From: "Lindgren, Donald A." <lindg1da@westinghouse.com>
To: "jnw@nrc.gov" <jnw@nrc.gov>
Date: Wed, Oct 12, 2005 3:17 PM
Subject: AP1000 Tier 1 Change Comment Responses

PROPOSED REVISION 15
AP1000 DESIGN CONTROL DOCUMENT

Tier 1 Subsection 2.1.3; Tables 2.1.3-1, 2.1.3-2, 2.1.3-3, and 2.1.3-4; and Figure 2.1.3-3
Reactor System

Figure 2.1.3-3
Reactor Vessel Arrangement

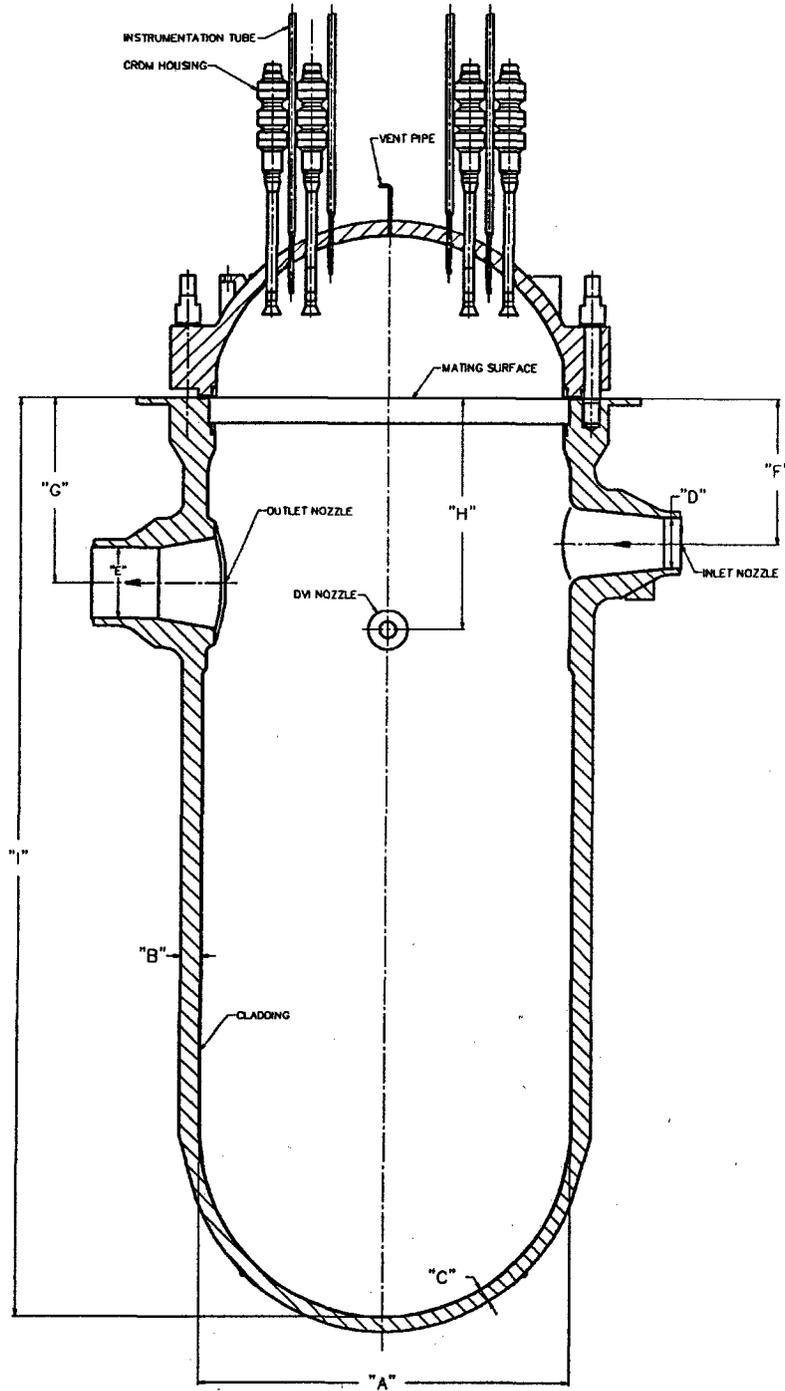
Comment: In figure 2.1.3-4 we changed the reactor vessel diameter. Tier 2 needs to be changed to be consistent.

The changes to GRCA tag numbers are corrections of the tag numbers. The change to Table 2.1.3-2 Item 7 is to clarify the first unit testing. The change to Tier 1 Table 2.1.3-2 Item 9 is to provide a precise reference for an ITAAC item. The change to vessel diameter is due to progress in detail design and supporting analysis. Editorial changes are self-evident.

Tier 1 Figure 2.1.3-3 Revise Tier 1 Figure 2.1.3-3 as shown on the next page.

Tier 2 Table 1.3-1 and 5.3-5, Subsection 5.3.1.2 and 5.3.4.1, and Figure 5.3-1 and 5.3-6 will be revised to be consistent with the changes in Tier 1 text and figures. A revised write-up for 2.1.3 is attached that shows the revised changes and includes the proposed Tier 2 changes (figures later) is attached.

Most of the changes reflect current fabrication practices; for example, a one-piece forged reactor vessel head is the standard replacement head configuration. The increase in vessel inside diameter in the core region by 2 inches helps to decrease the fluence on the vessel. The decrease in the vessel wall thickness near the nozzles makes welding the nozzles easier, and the resulting wall thickness is the same as in the Westinghouse Standard 3XL reactor vessels.
